City of Santa Barbara California

PLANNING COMMISSION STAFF REPORT

REPORT DATE: May 14, 2008
AGENDA DATE: May 22, 2008
PROJECT ADDRESS: 1837 ½ El Camino de la Luz (MST2002-00214/CDP2002-0008)
TO: Planning Commission
FROM: Planning Division, (805) 564-5470
 Jan Hubbell, AICP, Senior Planner *JH*
 Dan Gullett, Associate Planner *DG*

The purpose of the Planning Commission hearing is to consider certification of the proposed Final Environmental Impact Report (EIR) and approval of the requested discretionary applications for a proposed single-family residence at 1837½ El Camino de la Luz.

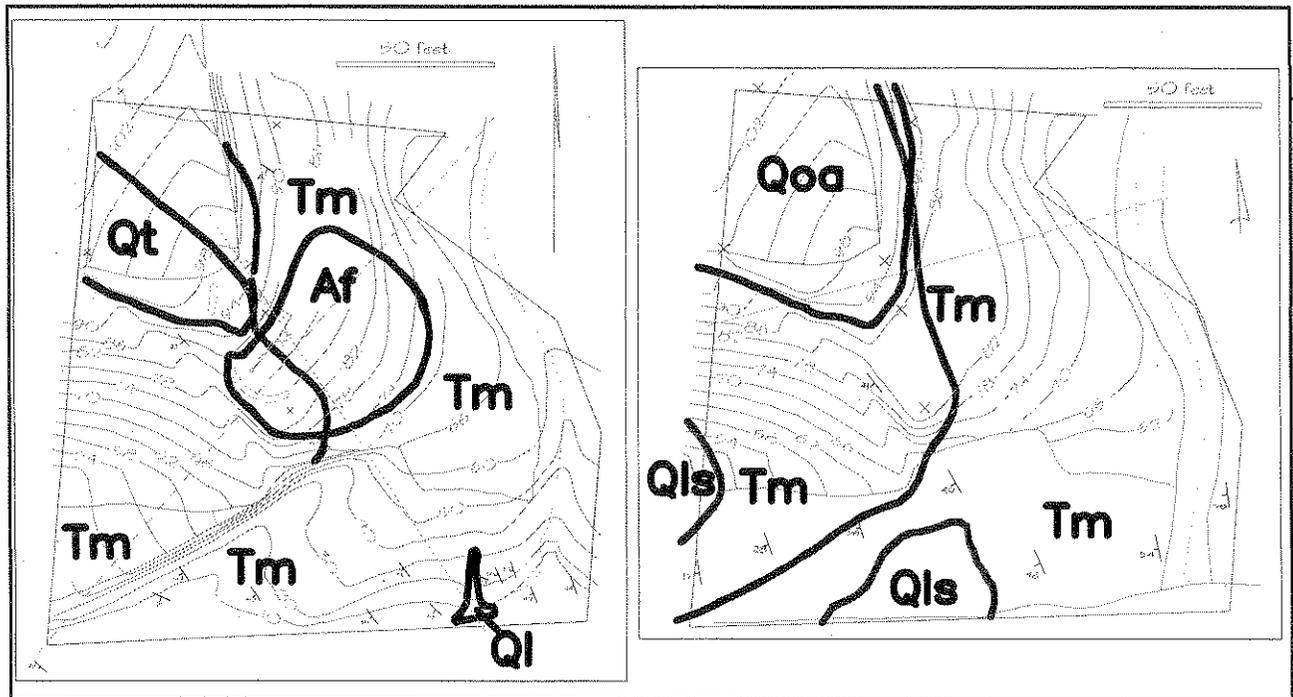
The maps in Figure 1 provide information for estimating where the feature Dr. Smith called a "continuously open bedding plane fissure of slide potential" is located on Dr. Barthels' property. A technique wherein the intersection between a dipping stratum and the surface topography can be determined was applied to each map by the writer to verify Dr. Smith's and CFG's results. Their results presumably were obtained using the same technique.

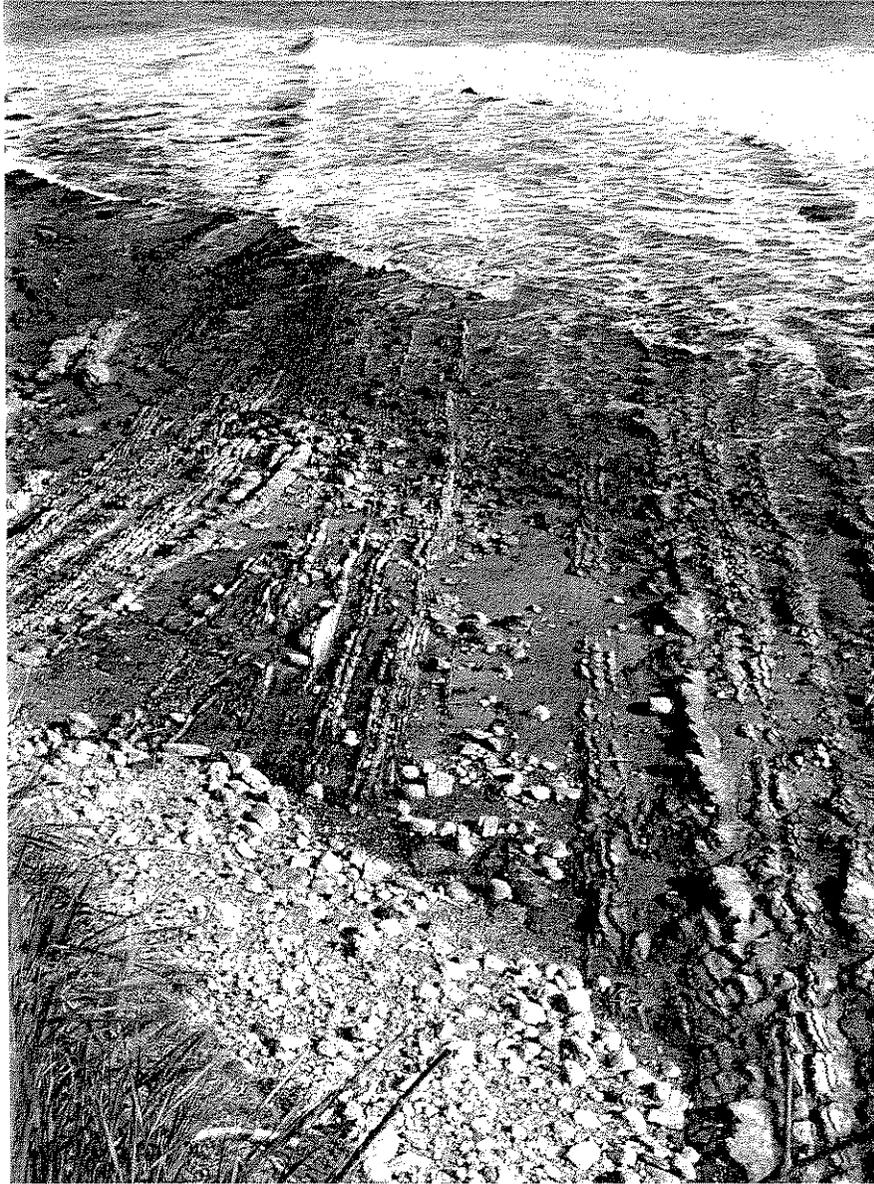
Next to the last line – This sentence contradicts the assertion made in the previous paragraph. Small, probably syngenetic folds have been noted on the subject parcel by Smith (1980), CFG (1996), Fisher (2001) and the writer (see Figure 2). These folds are extremely important because they represent asperities in bedding planes which strongly impede bedding plane slippage.

Figure 2 shows that the bedding planes of the Monterey strata at the site are not smooth planes as suggested by Mr. Knur, but are planes disrupted by the asperities of folds. The geologic maps of Smith (1980) and CFG (1996) both show folds in the Monterey strata. They also show that the dip of the strata is not uniformly 35°, but is variable from 17° to 25° at the beach, from 50° to 40° on the bluff and from 20° to 25° at the verge and bluff-top. Such small folds and homoclinal variation in dip in the true character of the orientation of the Monterey strata at the site. This character plus the obvious fractured nature of the strata should instruct one to expect a mode of failure other than a simple block slide down dip. This is further borne out by the nature of the block slide shown in Figure 2. That failure took place across the dip of the strata and the direction of motion appears not to have been down dip.
